**REGULAR MEETING OF THE UNITED LAGUNA HILLS MUTUAL
ARCHITECTURAL CONTROL AND STANDARDS COMMITTEE**

**Thursday, June 21, 2018 – 9:30 a.m.
Laguna Woods Village Community Center Sycamore Room
24351 El Toro Road**

DATE: June 21, 2018
FOR: Architectural Control and Standards Committee
SUBJECT: Variance Request: Mr. Mark Milker of 44-H (Barcelona, 10B)
Window to Door in Kitchen

DATE: June 21, 2018
FOR: Architectural Control and Standards Committee
SUBJECT: Variance Request: Mr. Michael Francis of 607-A (Valencia, 9)
Window/Door Modifications, Bathroom Split, and Vaulted Ceiling

ELEVATION
EXISTING KITCHEN WINDOW FROM EXTERIOR

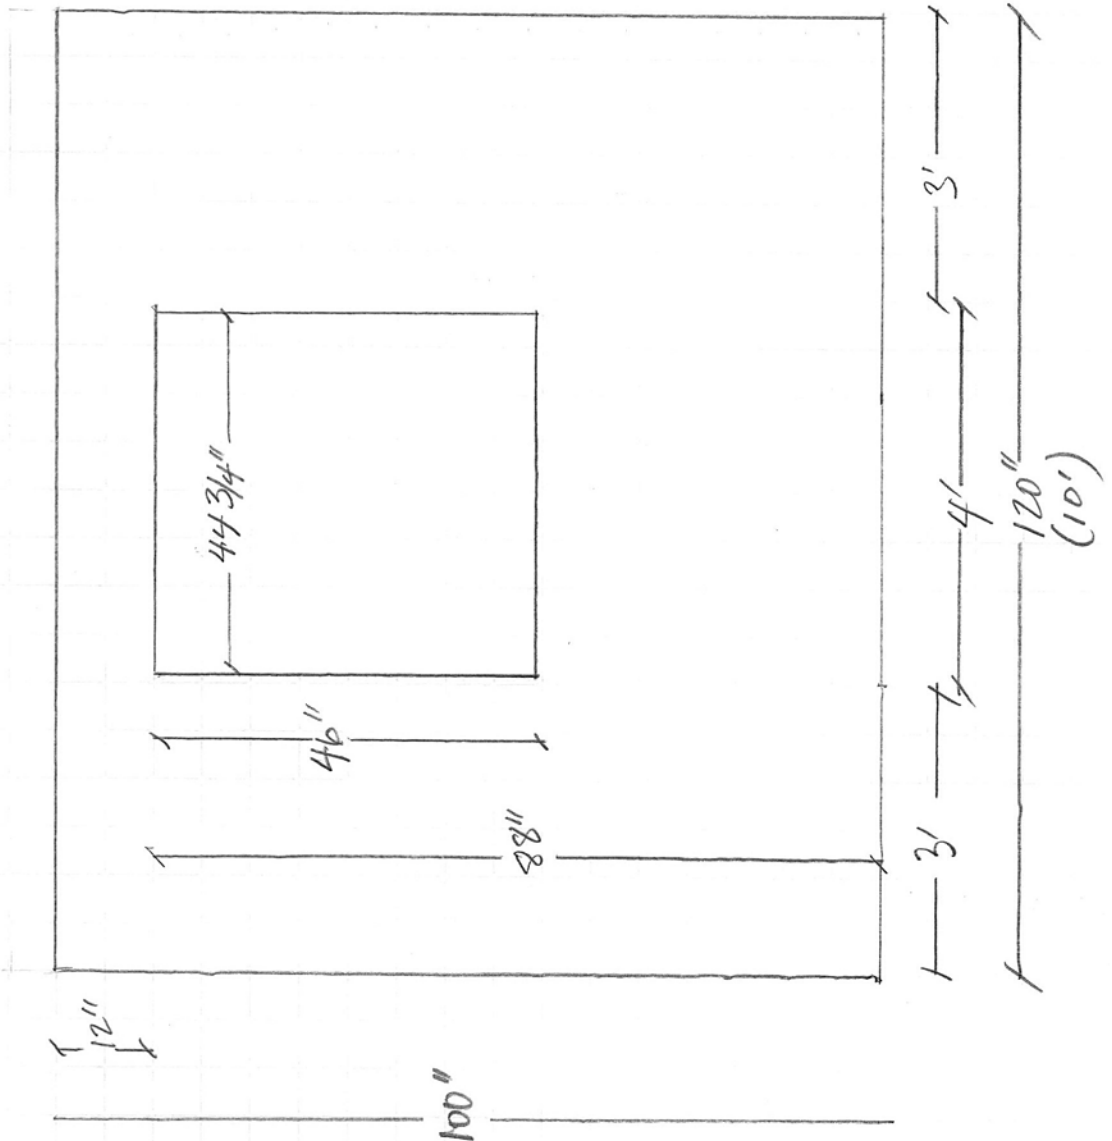
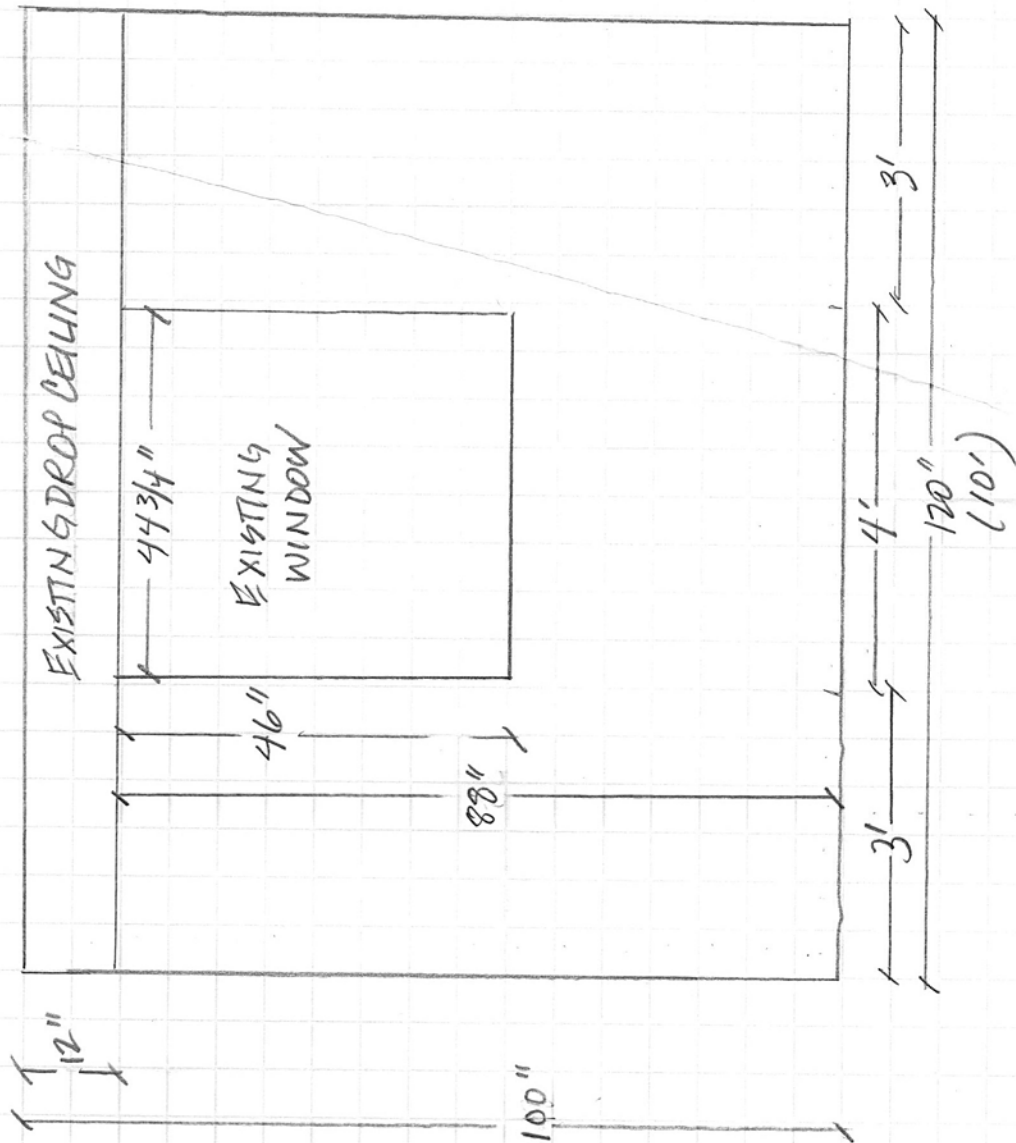
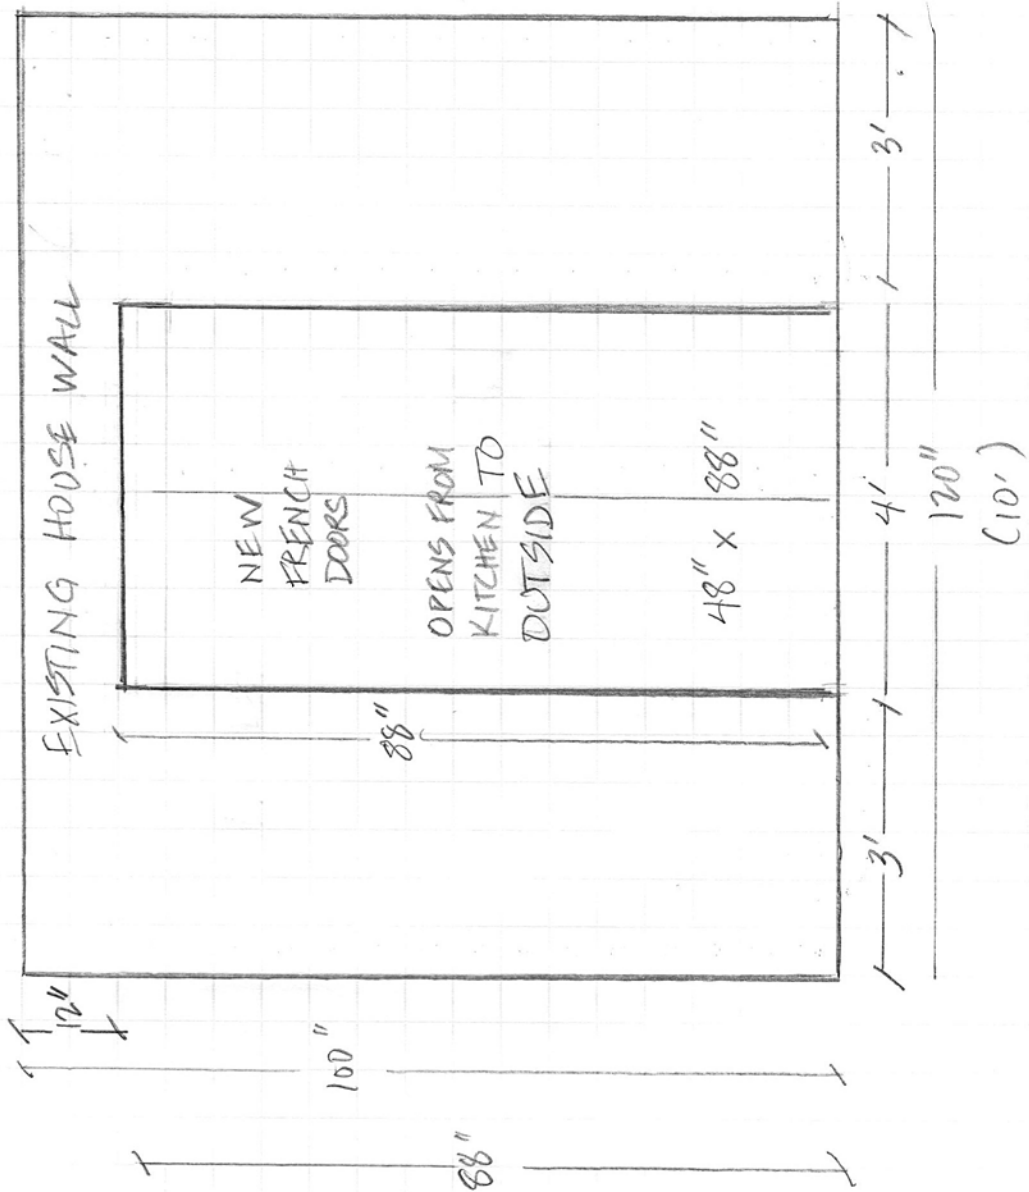
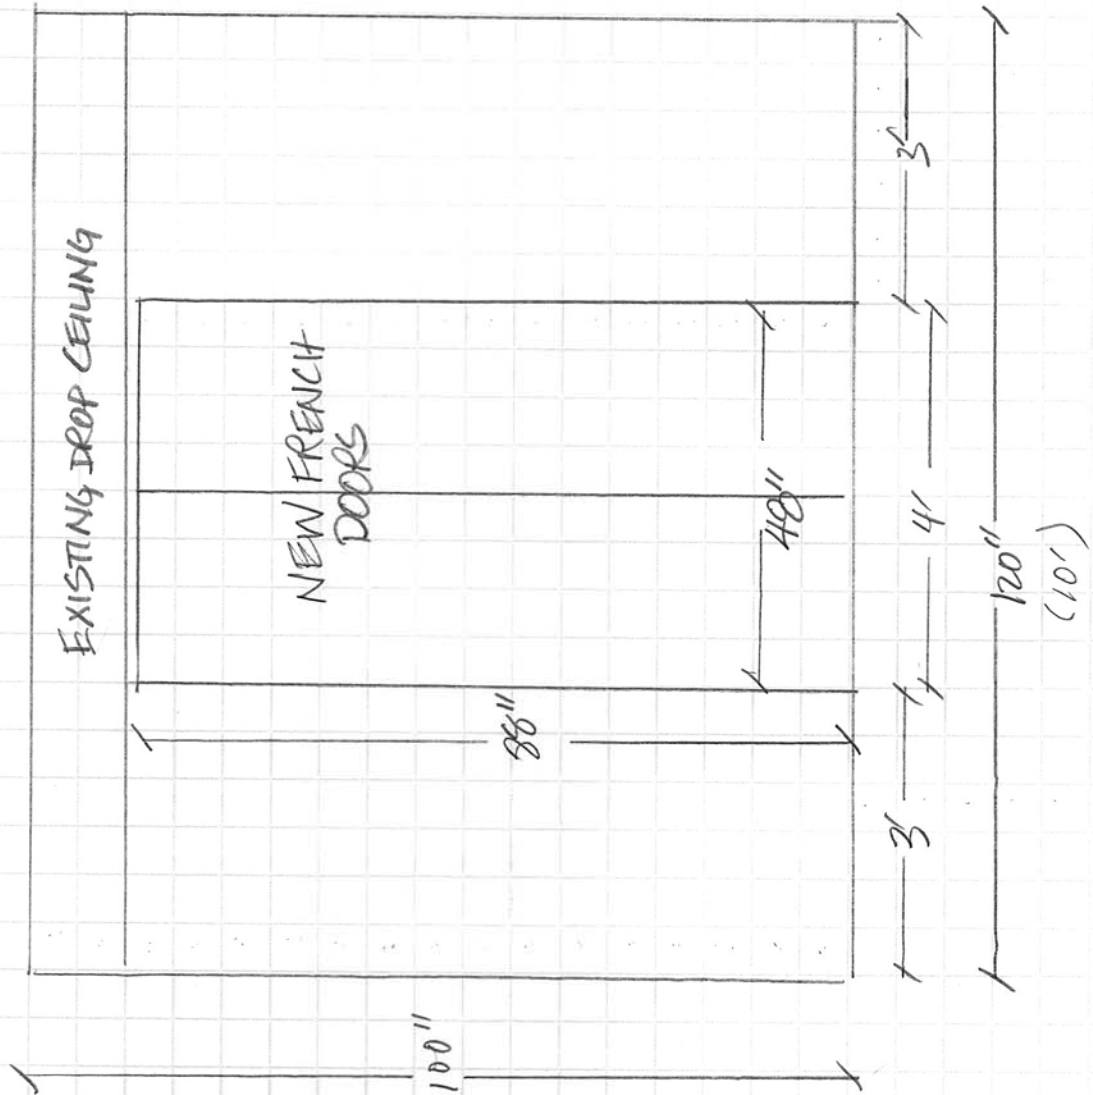
Mr. Milker is requesting to replace the existing 48" wide by 48" tall kitchen window and replace with a 48" wide by 88" tall French door.

The proposed doors will fit below the existing header and therefore would not require any structural modifications to the wall. The proposed doors are white French doors and will swing to the exterior.

Since this alteration will be within an enclosed patio (once completed) and not visible from the exterior, Staff does not believe the proposed window-to- door conversion would create a negative imbalance to the unit or the surrounding area.

Staff recommends the Board approve the request to convert the kitchen window to a door with the conditions stated in Appendix A.

FLOOR PLAN
SCALE 1/4"=1'-0"

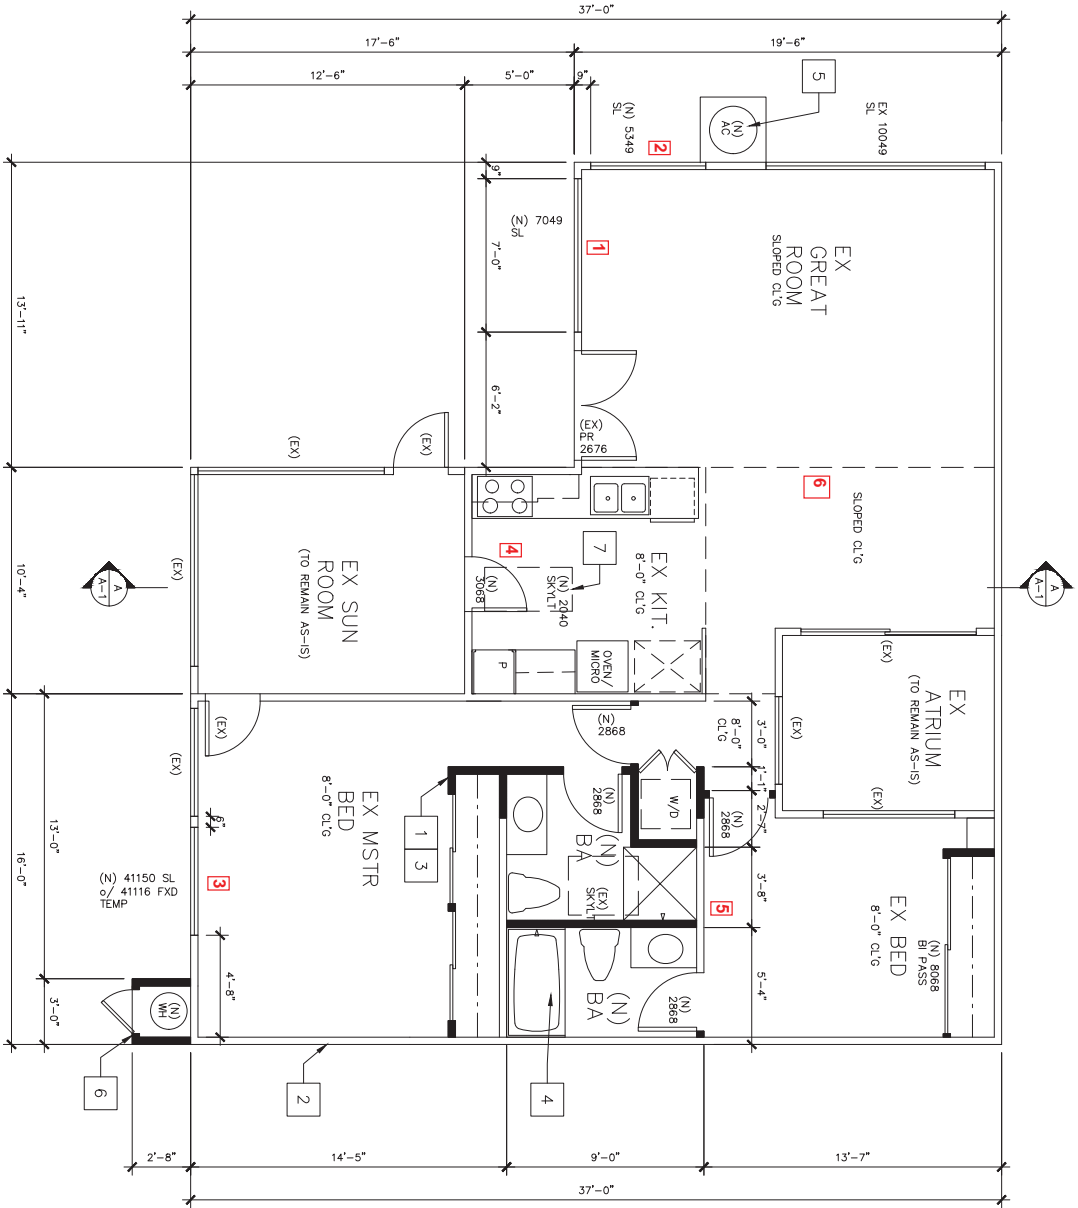
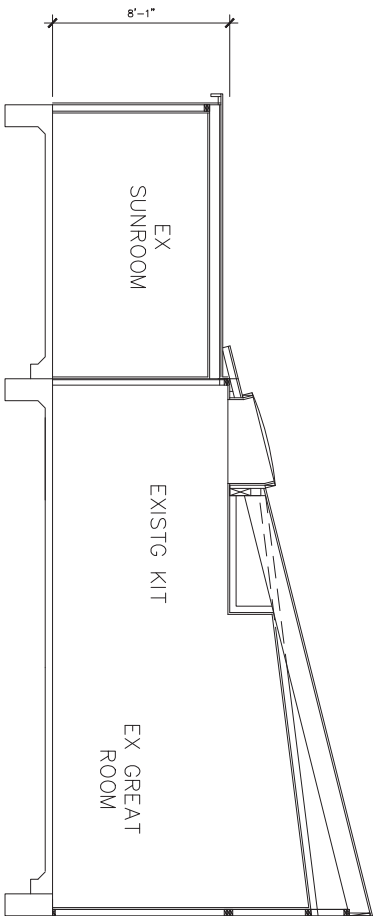
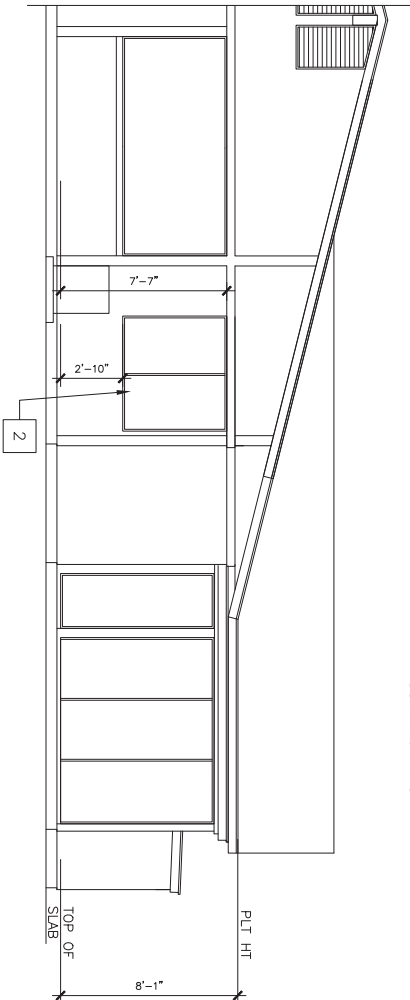
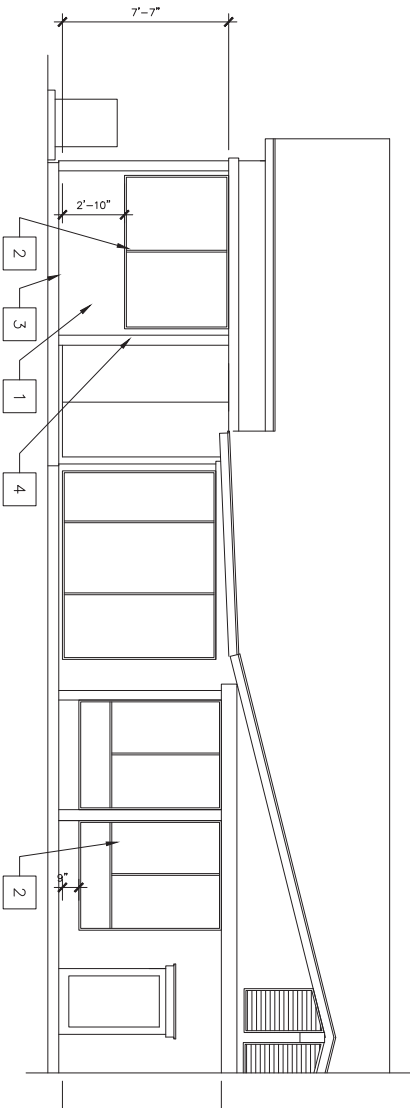
(3) Install Window in Master Bedroom: The variance request also proposes to install a matching second window in the bedroom that would measure 4'11" wide, and consist of a 1'6" tall fixed window with a 5' tall sliding window above to match the existing. Since the wall in question does not face any other building, Staff feels the visual impact would be minimal.

(4) Replace Kitchen Window with Door: Mr. Francis proposes to replace the existing 4' wide by 4' tall kitchen window with a door measuring 3' wide by 6'8" tall. Due to the existing header being taller and wider than the proposed door, no structural changes would be needed to accommodate this alteration. Staff does not see any negative effects of approving the alterations due to the door's location within an enclosed patio.

(6) Vault Ceiling in Dining Room and Hallway: Mr. Francis proposes to replace the existing trusses in the kitchen, dining room and hallway with a rafter system to raise the ceiling to extend the vaulted ceiling from the living room into the dining room and hallway area. The kitchen's ceiling would also be raised from 7'6" to 8' as part of the alteration. Due to there being an existing ceiling policy that prohibits the modification of a units roof structural members, Staff recommend denial of this requested item.

(1) Proposed front living room window location

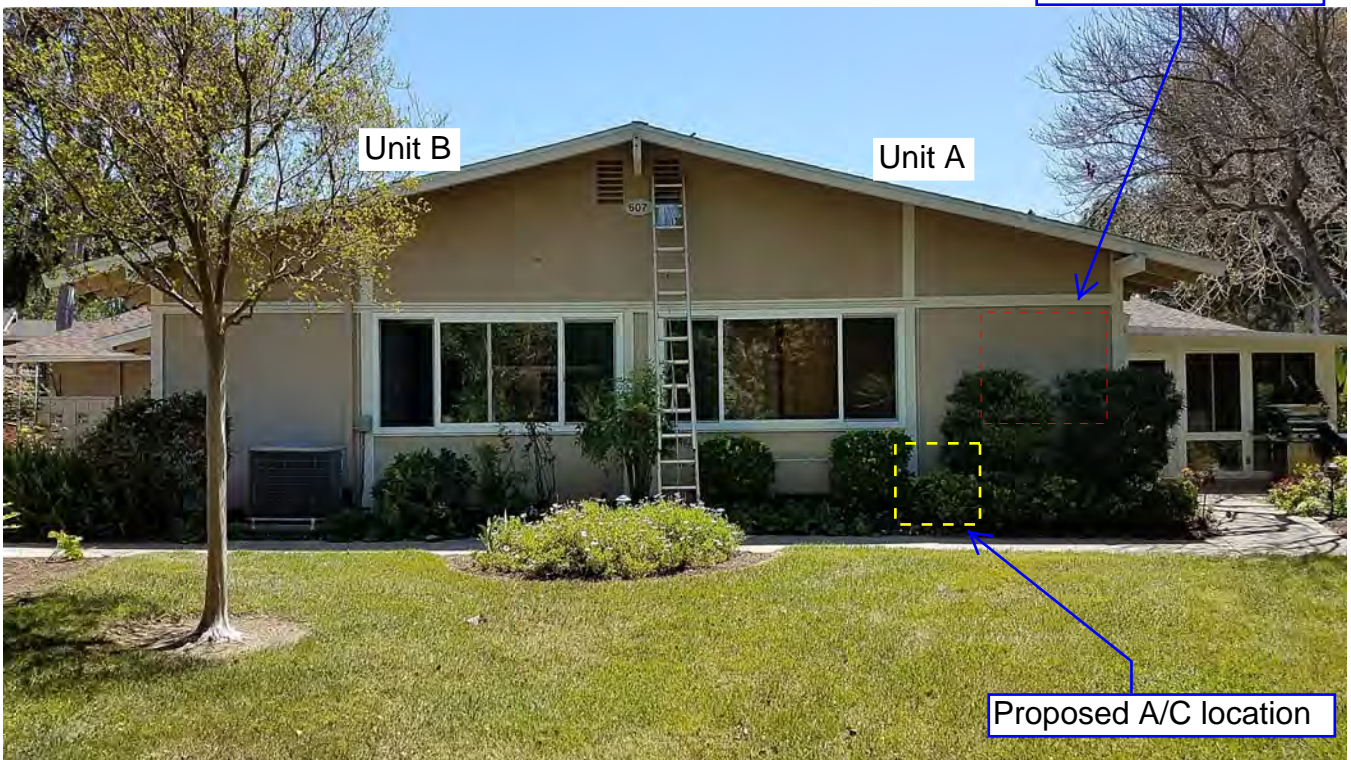
1. Install new front window in living room by entry door.
2. Install new side window in living room by existing living room window.
3. Install window in master bedroom.
4. Replace kitchen window with door.
5. Bathroom Split.
6. Replace existing ceiling with vaulted ceiling in dining room and hallway to match living room.
